## Product Change Notice (PCN)

**Subject:** Change of Waffle Pack Label Display

**Publication Date:** 7/6/2021

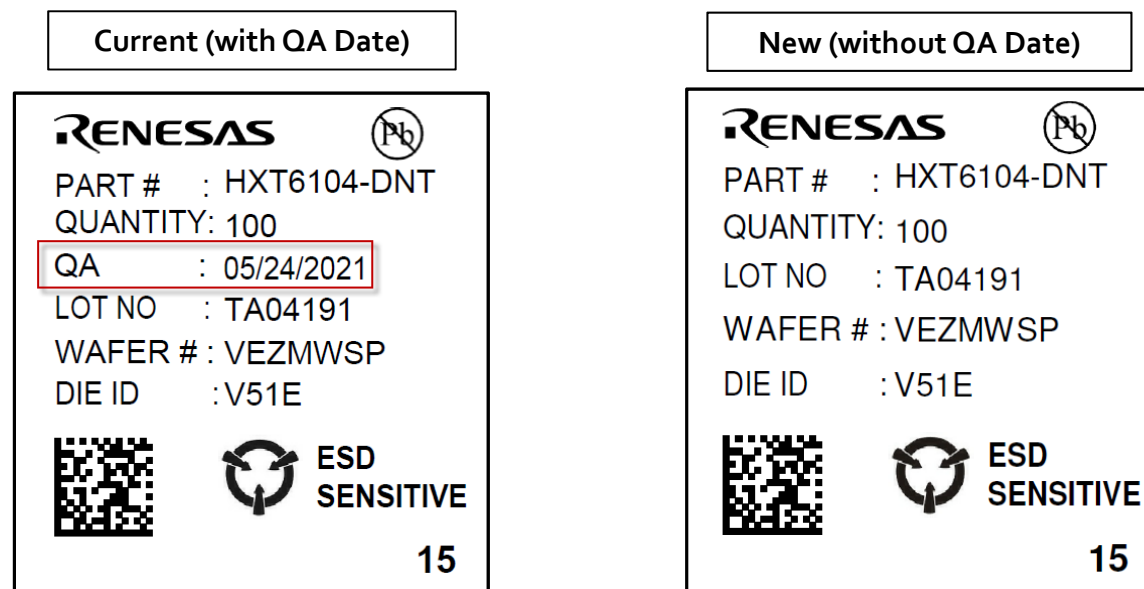
Renesas is updating the waffle pack label by removing the QA date from the label display. Others remain unchanged. Refer sample label changes as depicted below.
